TECHNICAL SERVICE BULLETIN, VIN: WSB-07 Open Trail Secondary Alternator Replacement

Technical Service Bulletin WSB-07 Repair Instructions

Purpose: Replace alternator with alternator with updated firmware.

Models: 2025 & 2026 Open Trail Motorhomes

Figure 2

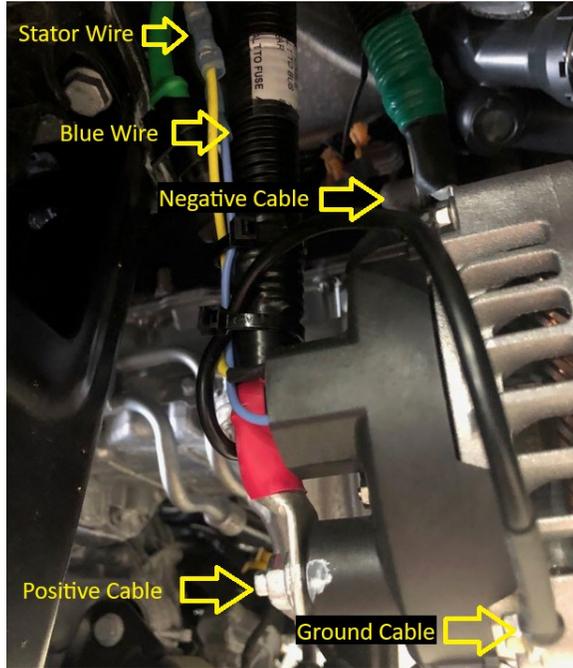
2. Remove existing secondary alternator from mount. Remove positive cable and wrap cable end with electrical tape to prevent any contact. Remove negative cable and then use wire cutters to remove blue wire. Remove ground cable. See Figure 2 for secondary alternator diagram.
3. Install new secondary alternator (5169450). Connect positive cable and torque to 18 ft-lbs. Connect negative cable and torque to 18 ft-lbs. Use a butt connector to connect blue wire. Locate yellow stator wire located in the harness and use butt connector to connect to yellow stator wire on alternator. Connect ground cable and torque to 30 ft-lbs. See Figure 2 for new secondary alternator diagram.
